**ERRATA SHEET FOR  
ANSI/ASHRAE/IES STANDARD 90.1-2019 (SI Edition)  
Energy Standard for Buildings Except Low-Rise Residential Buildings**

**May 20, 2021**

The corrections listed in this errata sheet apply to ANSI/ASHRAE/IES Standard 90.1-2019, SI Edition. The first printing is identified on the outside back cover of the standard as “Product code: 86272 1/20”. Shaded items have been added since the previously published errata sheet dated April 8, 2021 was distributed.

Figure 3.2-5 Computing the secondary sidelighted area.

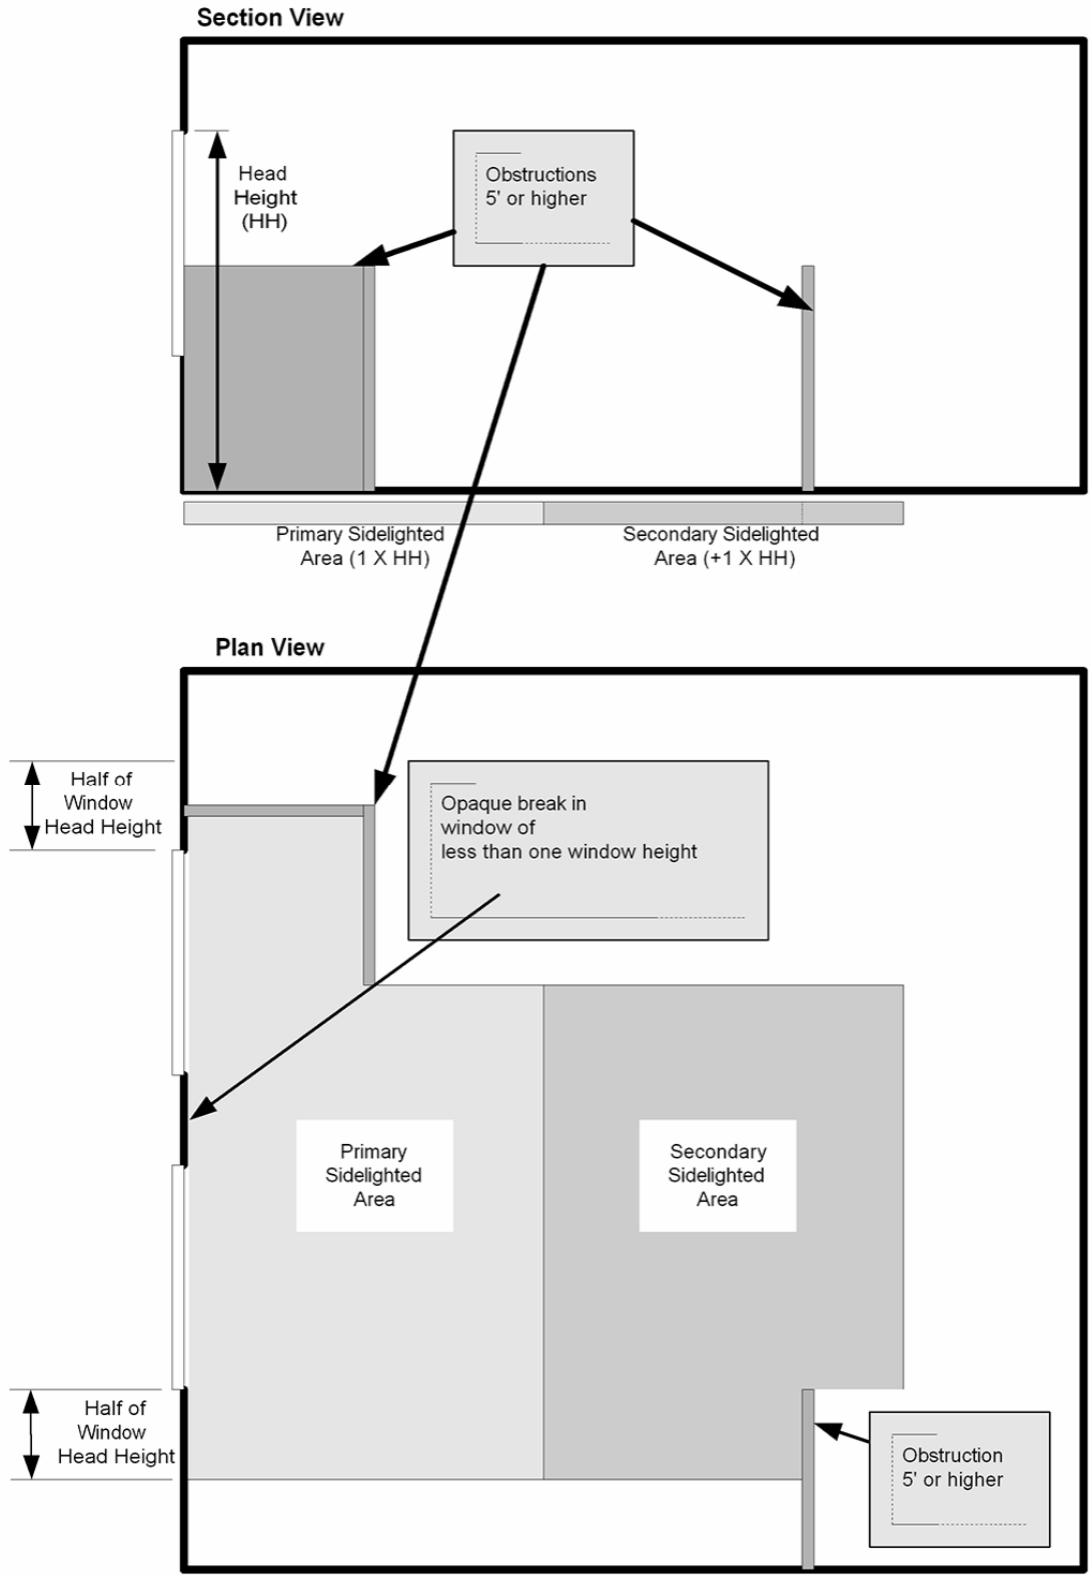
- 260 **Equations A9.4-2.** In Equation A9.4-2 replace “A = 0.00258168” with “A = 0.0258168”.
- 265 **Equations A9.4-22.** In Equation A9.4-22 replace “A = 0.00258168” with “A = 0.0258168”.
- 271 **Table 9.4.2-1 Values for Cavity Air Spaces<sup>a</sup>.** Change the title of Table 9.4.2-1 to “**R-Values for Cavity Air Spaces<sup>a</sup>**”.
- 287 **Informative Appendix E Informative References.** Update the references as shown below. See also the revised table from Informative Appendix E attached with changes shown in red text.  
(Note: Additions are shown in underline and deletions are shown in ~~strikethrough~~.)
